Vermont Agency of Transportation
RECEIVED
 CK'D BY NA/AG OK'D BY JS
 March 24, 2015
 RESUBMIT YES Rejected
 BY KH DATE 3-30-2015

I-91 NB LEFT LANE CLOSURE (BARRELS)

PROJECT NAME: HARTFORD	FILE NAME: sl2a026_NB Left Closure.dgn	PLOT DATE: 03/24/15
PROJECT NUMBER: IM 091-2(79)	PROJECT LEADER: K. HIGGINS	DRAWN BY: B. LYON
	DESIGNED BY: B. LYON	CHECKED BY: S. SAWYER
	I-91NB LEFT LANE CLOSURE (BARRELS)	SHEET 32 OF ??

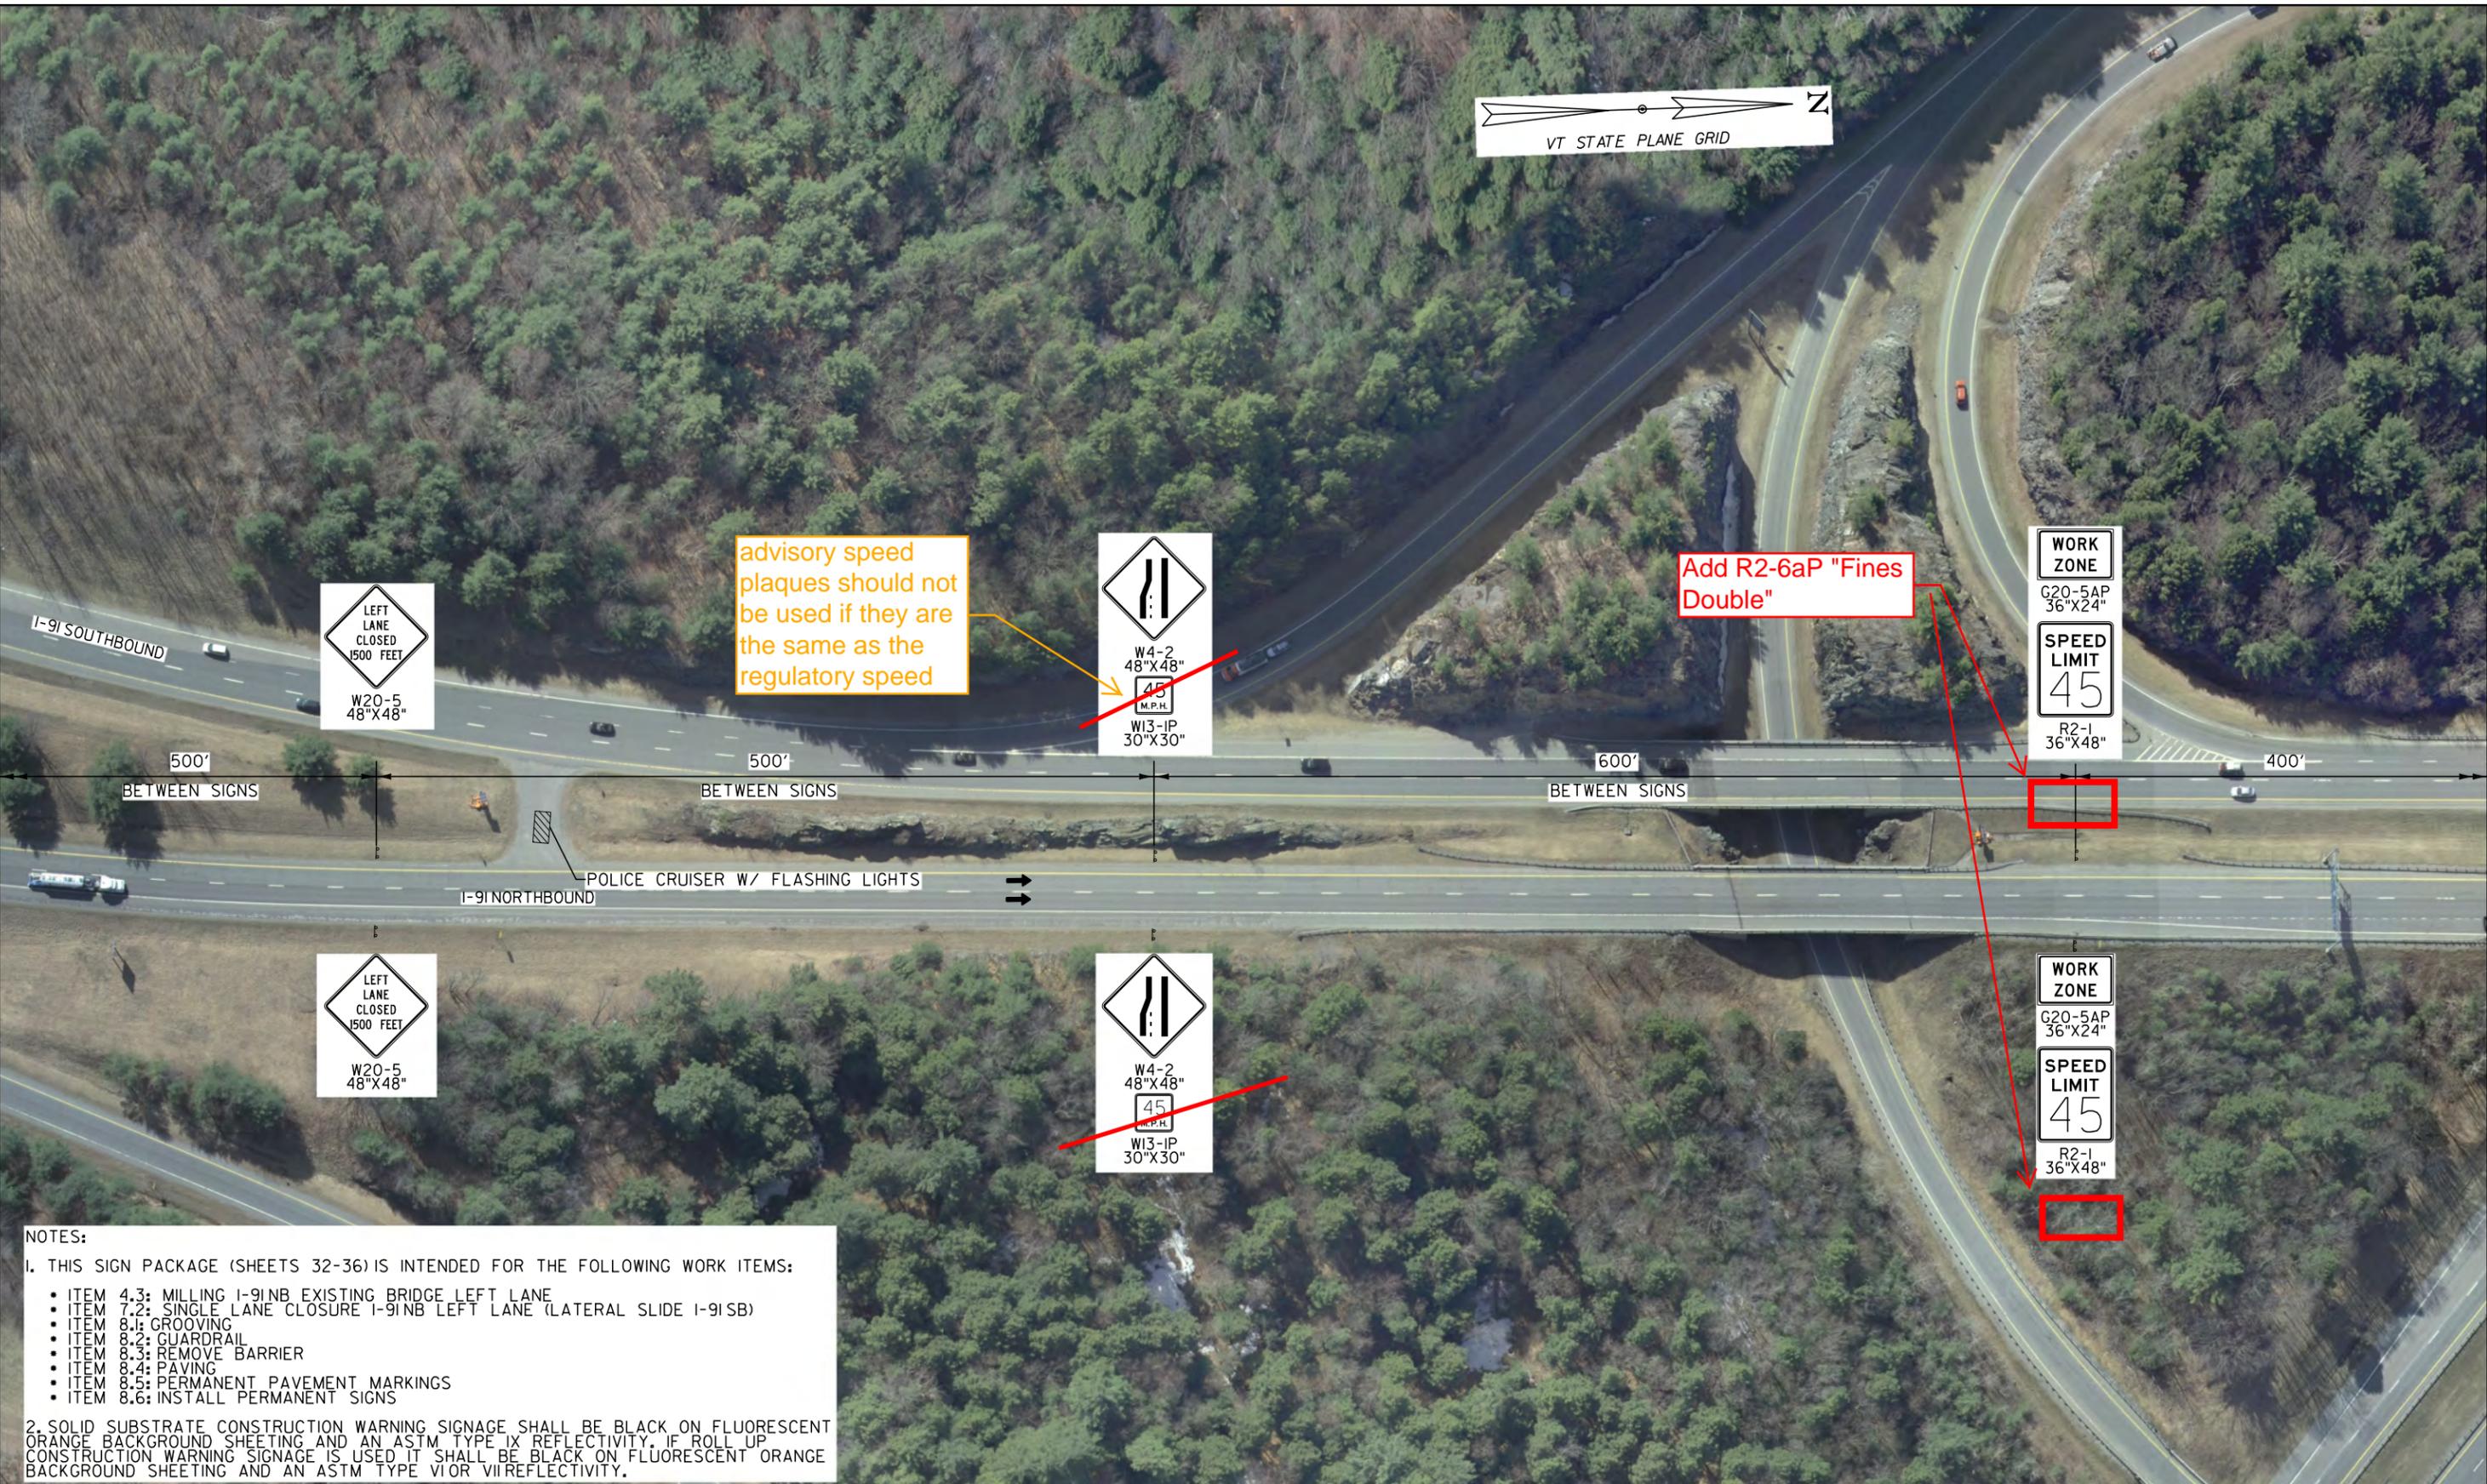
these should be part of the long term approach sign package.

All permanent signs should be post mounted.

The VR-355 can be omitted if an R2-6aP "FINES DOUBLE" plaque is added to the bottom of the speed limit assembly (G20-5aP + R2-1)

advisory speed
plaques should not
be used if they are
the same as the
regulatory speed

Add R2-6aP "Fines
Double"

PROJECT NAME: HARTFORD	PLOT DATE: 03/24/15
PROJECT NUMBER: IM 091-2(79)	DRAWN BY: B. LYON
FILE NAME: sl2a026.NB Left Closure.dgn	CHECKED BY: S. SAWYER
PROJECT LEADER: K. HIGGINS	SHEET 35 OF ??
DESIGNED BY: B. LYON	
I-91NB LEFT LANE CLOSURE (BARRELS)

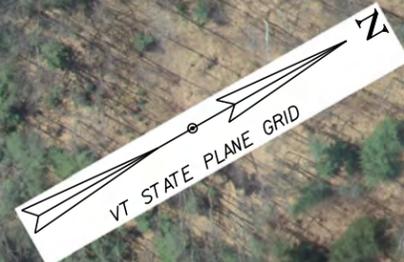
I thought when we reviewed the approach sign package that we had moved the ERW beyond the on-ramp so that it caught the drivers coming out the US 5 WZ as well.

PROJECT NAME: HARTFORD
PROJECT NUMBER: IM 091-2(79)
FILE NAME: sl2a026_NB Right Closure.dgn PLOT DATE: 03/24/15
PROJECT LEADER: K. HIGGINS DRAWN BY: B. LYON
DESIGNED BY: B. LYON CHECKED BY: S. SAWYER
I-91NB RIGHT LANE CLOSURE (BARRELS) SHEET 38 OF ??

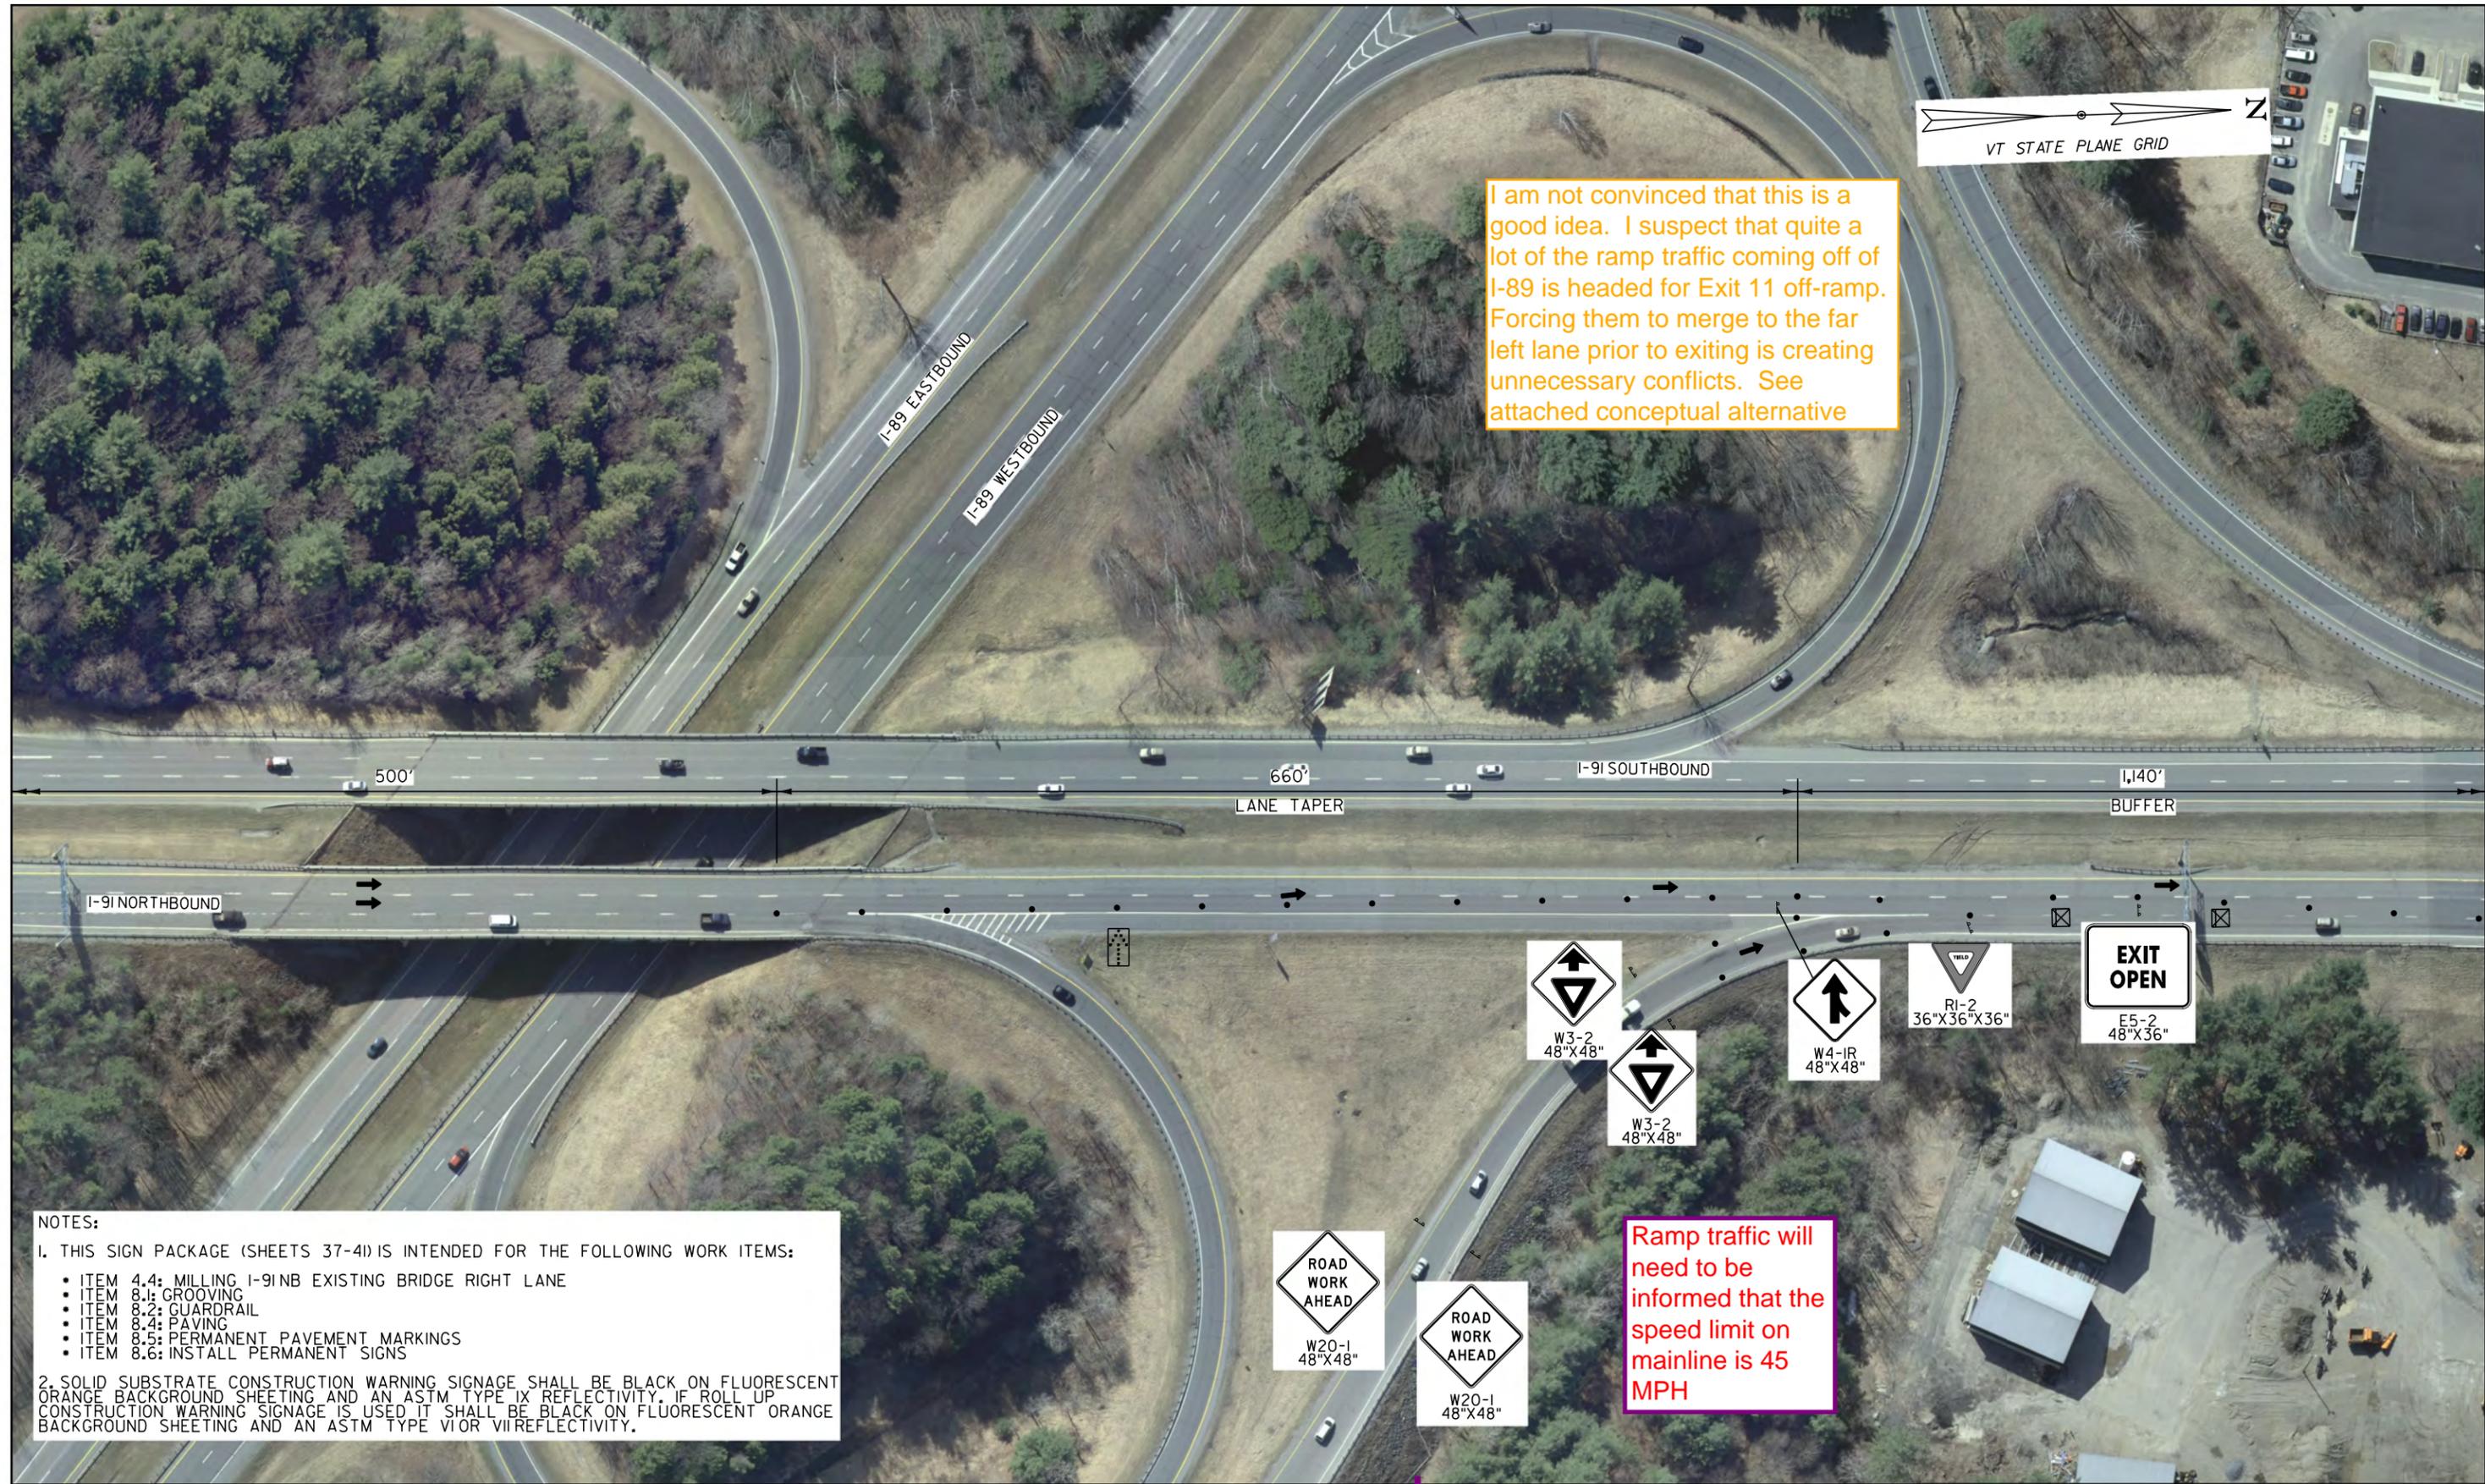
I am not convinced that this is a good idea. I suspect that quite a lot of the ramp traffic coming off of I-89 is headed for Exit 11 off-ramp. Forcing them to merge to the far left lane prior to exiting is creating unnecessary conflicts. See attached conceptual alternative

Ramp traffic will need to be informed that the speed limit on mainline is 45 MPH
